**Re: Proposed design at 7601 E Polk Street, Scottsdale 85257**

**From:** commissionerkaminski@gmail.com  
**Sent:** Wednesday, March 26, 2025 7:25 AM  
**To:** Zimmer, Christopher  
**Subject:** 32-DR-2024 The Arden

**From:** Mailen P <luz.mailen@gmail.com>  
**Sent:** Thursday, September 11, 2025 9:44 AM  
**To:** Zimmer, Christopher  
**Subject:** 32-DR-2024  
**Attachments:** 32-DR-2024 south scottsdale 3.pdf

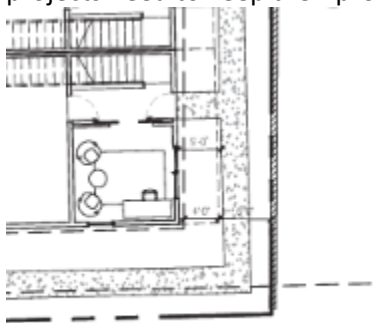
One concern I have is the distance between the east side apartments to the property line on the east where there are existing condominiums (owner occupied product). At the narrowest point it appears the Building B will be 10' from the property line and at the widest 19' from the property line, inclusive of a 3' wide sidewalk, leaving limited room for tree growth between the perimeter wall and the new buildings. I'm wondering if Ghost Gum might be more appropriate as a fast growing screen tree on the east side. This would provide more biodiversity and tie into the existing landscape character of the area with existing eucalyptus trees. I would suggest changing the pistache to ghost gum on the east side. As a separate note, looking at an aerial, Scottsdale Casitas to the north is missing landscape in their landscape islands and south side perimeter. Can you please mention this to code enforcement? Existing projects need to keep their properties up to maintain the appearance.

The existing condominiums are 2 story and have some trees along the west side for privacy, but what is the long term sustainability of the proposed landscape plan in relationship to the existing trees? Pistach canopies will need to be trimmed to prevent encroachment onto the adjacent landscape, and as a deciduous tree will provide sunlight to the existing plants for a portion of the year (but will also not provide privacy during that time). The proposed trees cascalote will fit the space but not provide privacy on the upper floors, as they are a patio tree. Can the landscape plan show the relationship of the existing buildings and trees to the east as a 50% screened image to show the relationship of windows on each project and relationship of tree plantings, hopefully staggered to accommodate healthy mature growth of plants on both sites?

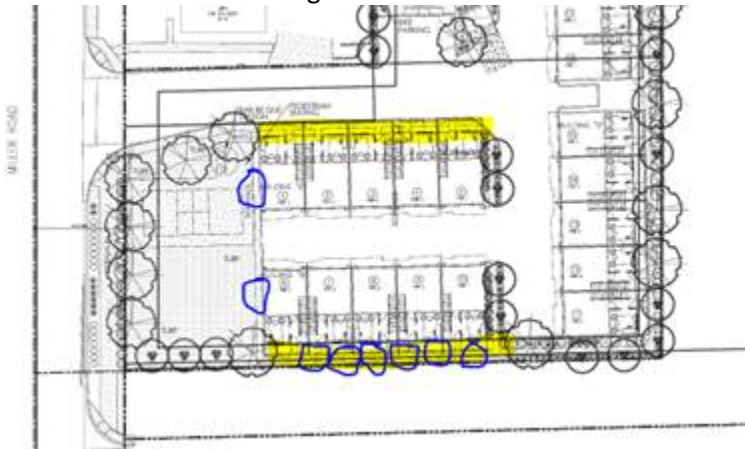
The site plan references an existing 6' high perimeter wall, this is not the case on the south side of the site, where new residences are being built adjacent to a commercial site. I would recommend that they

provide a 6' CMU wall with 2' of steel picket on top to secure the new apartments from access from the parking area to the south.

The units on the south of the site have no landscape at all separating them from the commercial uses to the south. This also provides no shade on the southern side of these buildings. Why is there no landscape shown adjacent to the patios on these units on the main drive into the site? there should be landscape along the drive in front of these units. There should also be trees on the western side of the units to shade the building.

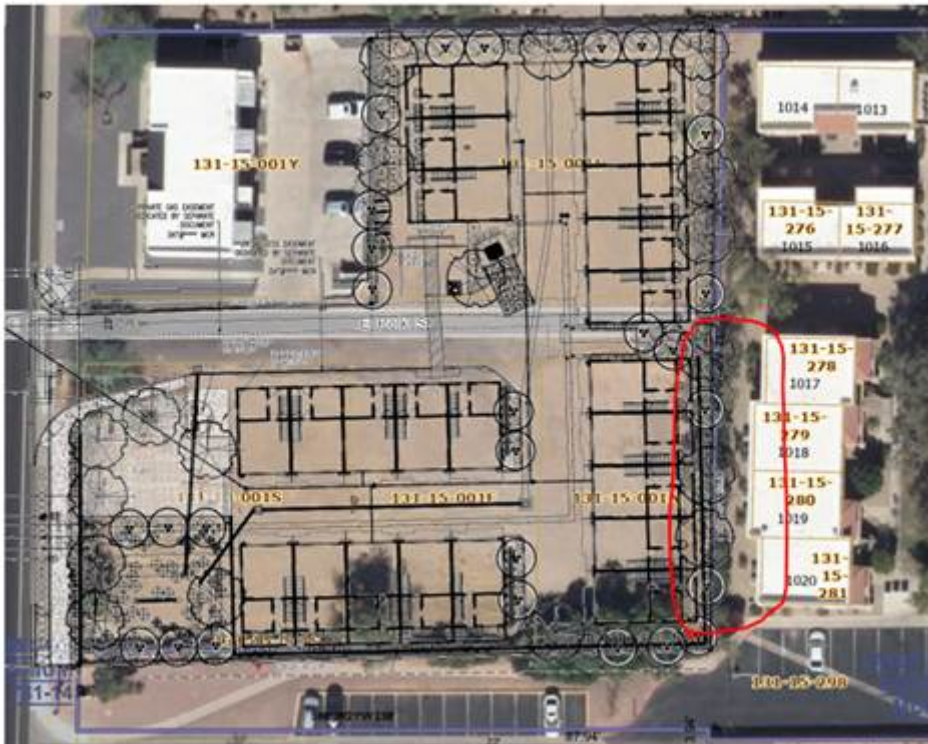
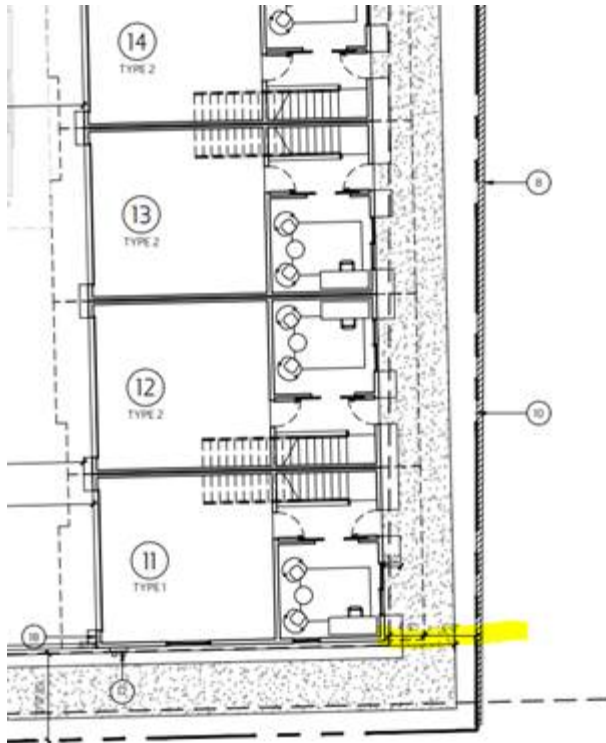
Please clarify if these are apartments, multi-family not single-family product. The building type is non-separated and it did not appear to have property lines being platted. The site plan calls these single-family residences which is misleading; it does not appear that these are owner-occupied opportunities but apartments made to look like townhomes. I wish staff would require applicants to clearly identify the product type and not misrepresent what is being built.

**I would like to propose the following conditions of approval be added by the Design Review Board:**

1. Based on the site plan notation of single-family townhome product, the project be platted as individual fee-simple lots with fire separation walls and individual utilities and mechanical systems as an owner-occupied product with applicable CC&Rs for the establishment of an HOA.

2. The eastern buildings shall be shifted west to equal the setback of the CASA DE AMIGOS CONDOMINIUM.
3. The east side shall provide a landscape strip a minimum of 8' in width, with sufficient room for tree canopy growth without encroachment into the adjacent condominium property on the eastern side of the site.

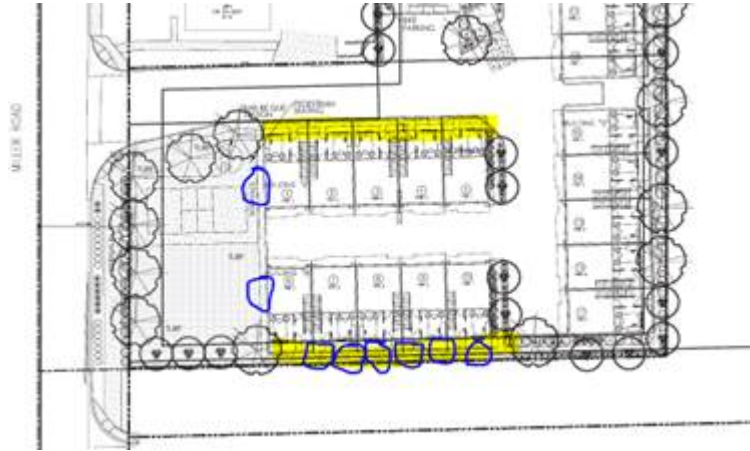
The units on the south of the site have very little landscape separating them from the commercial uses to the south. This also provides no shade on the southern side of

these buildings. Why is there no landscape shown adjacent to the patios on these units on the main drive into the site? there should be landscape along the drive in front of these units. There should also be trees on the western side of the units to shade the building.

# The Arden

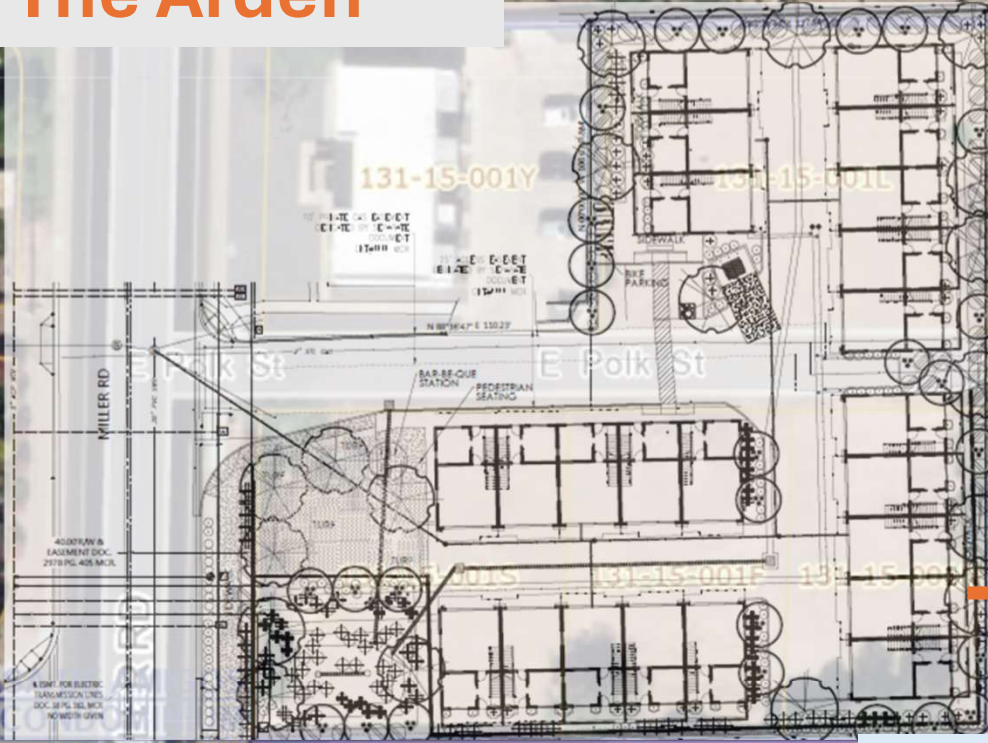
**21 ft setback at closest point**

Direct view from balconies at the Arden into bedroom windows at Casa de Amigos at less than 21 ft distance

The Arden (R-5)	Casa de Amigos (R-5)
3 stories	2 stories
No setbacks, instead, a pop out at 2 <sup>nd</sup> and 3 <sup>rd</sup> stories	No setbacks

# Unprecedented neighborhood design

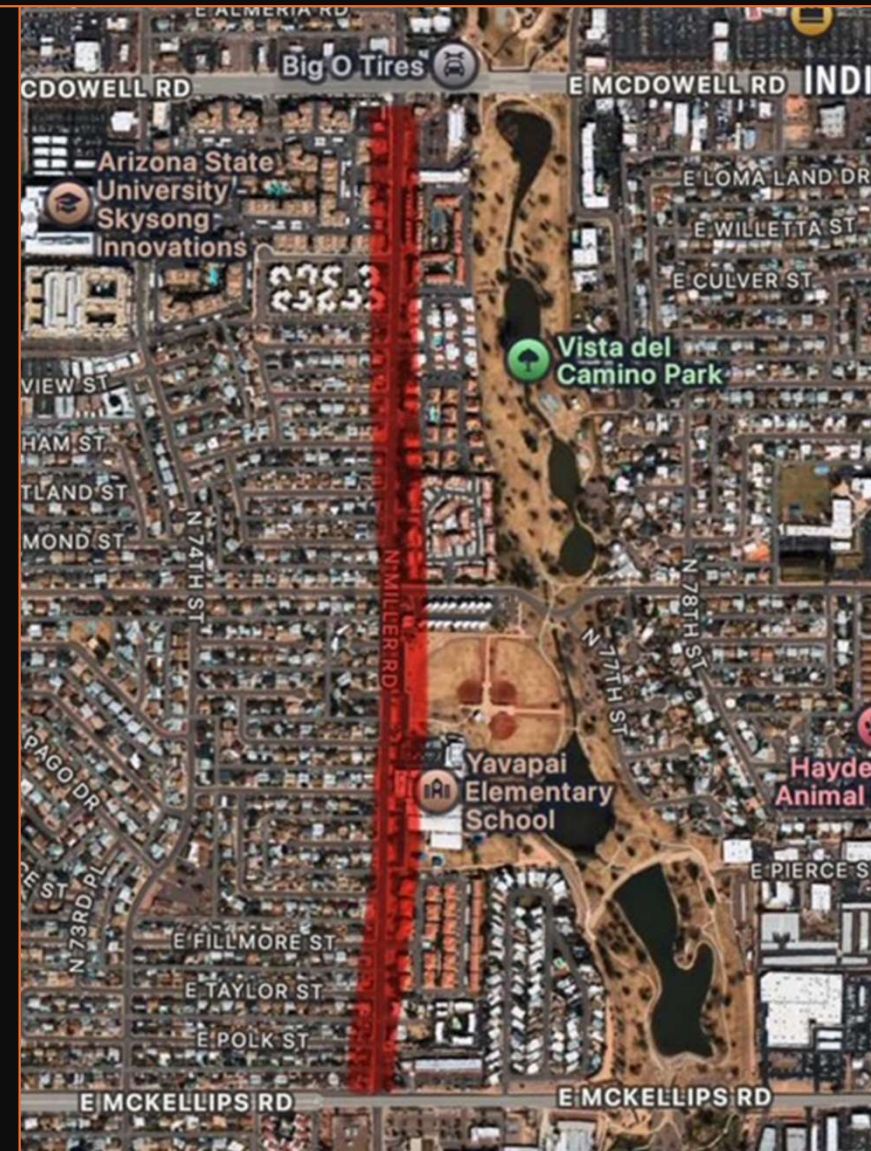
These will be two, 100 ft long, 33 ft high walls of contiguous balconies looking into our bedroom windows. In my case, the balconies will be 21 ft away from my bedroom windows
